Our Ref: 24029  
Doc Name: 20250321 Melton East PSP Submission - RAL  
RAL/ral

21 March 2025

**Melton East PSP and Proposed Rezoning  
367- 429 Tarletons Rd, Bonnie Brook**

**Plan 3** of the PSP document – Housing - appears to indicate future open space (amenity) over the subject land:

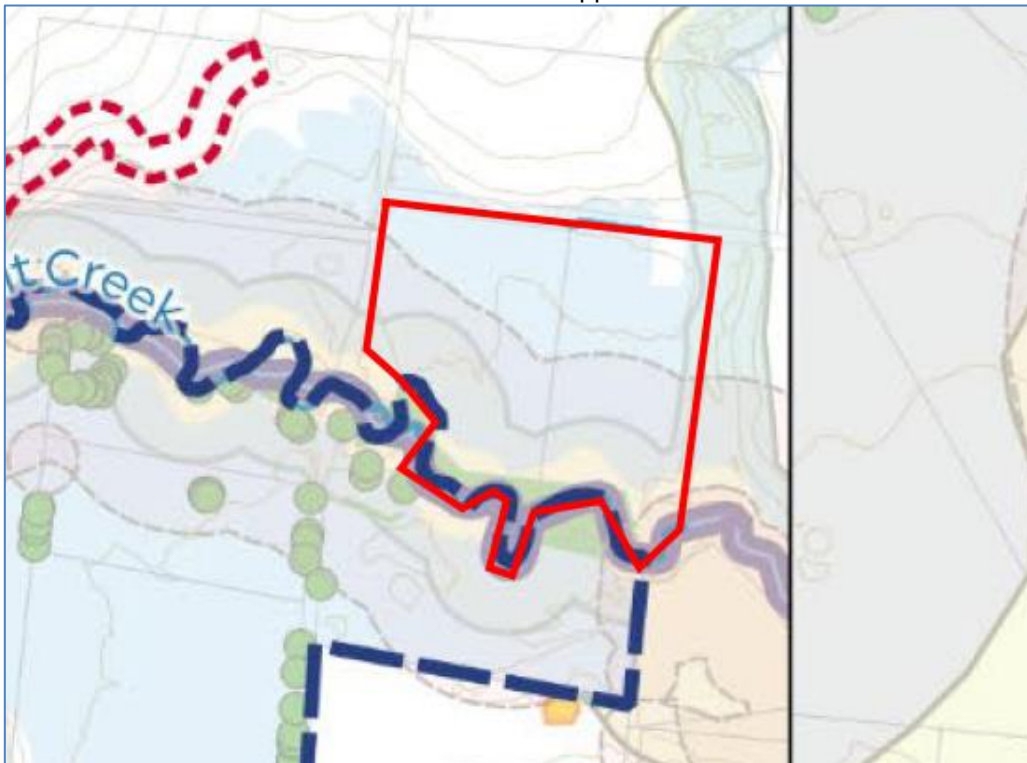
The inclusion of this designation has no basis and does not reflect any investigation outcomes. Therefore, all indicated “green” areas outside of the boundaries of the PSP must be deleted from plan 3.

**Plan 10** of the PSP document – Aboriginal Cultural Values – indicates an area of cultural heritage sensitivity within the southern half the land. Refer also to Plan 17 at Appendix 9.

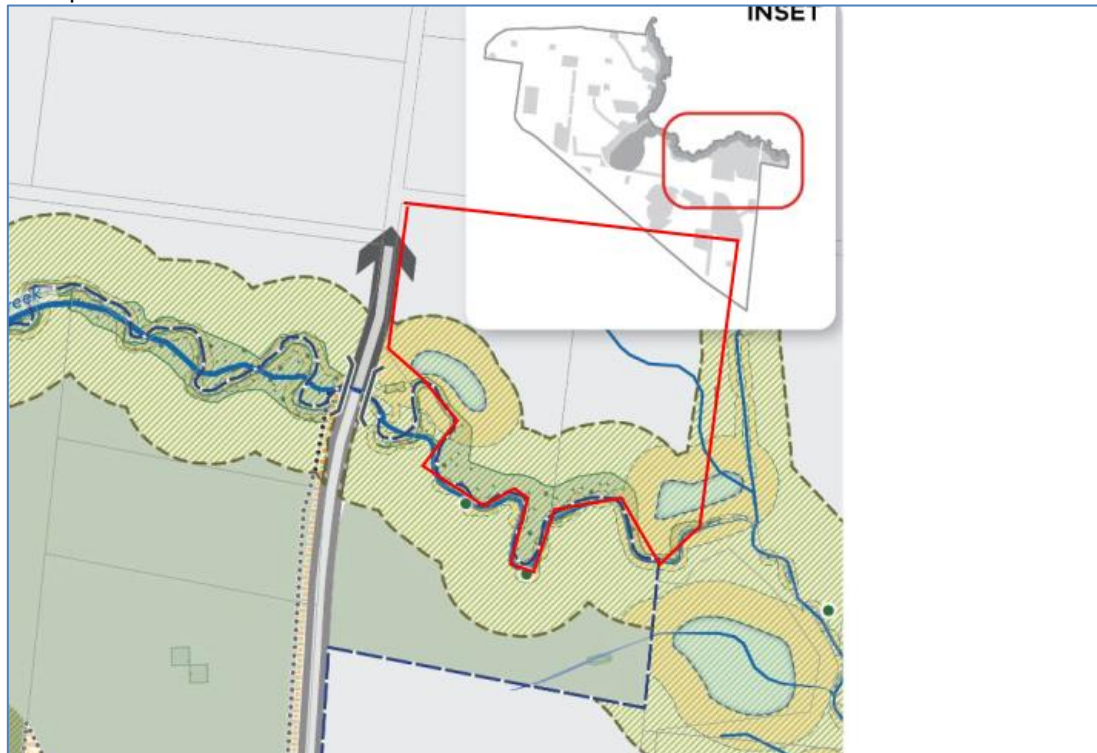
This is based on the proximity to the Kororoit Creek and has no consideration for the significant disturbance that has occurred previously on the land, which in accordance with the Aboriginal Heritage Act regulations, means the land has no cultural heritage significance. Cultural heritage issues related to the land will be

considered in conjunction with the Warrensbrook PSP. The land is not within the Melton East PSP and this designation must be deleted from plan 10.
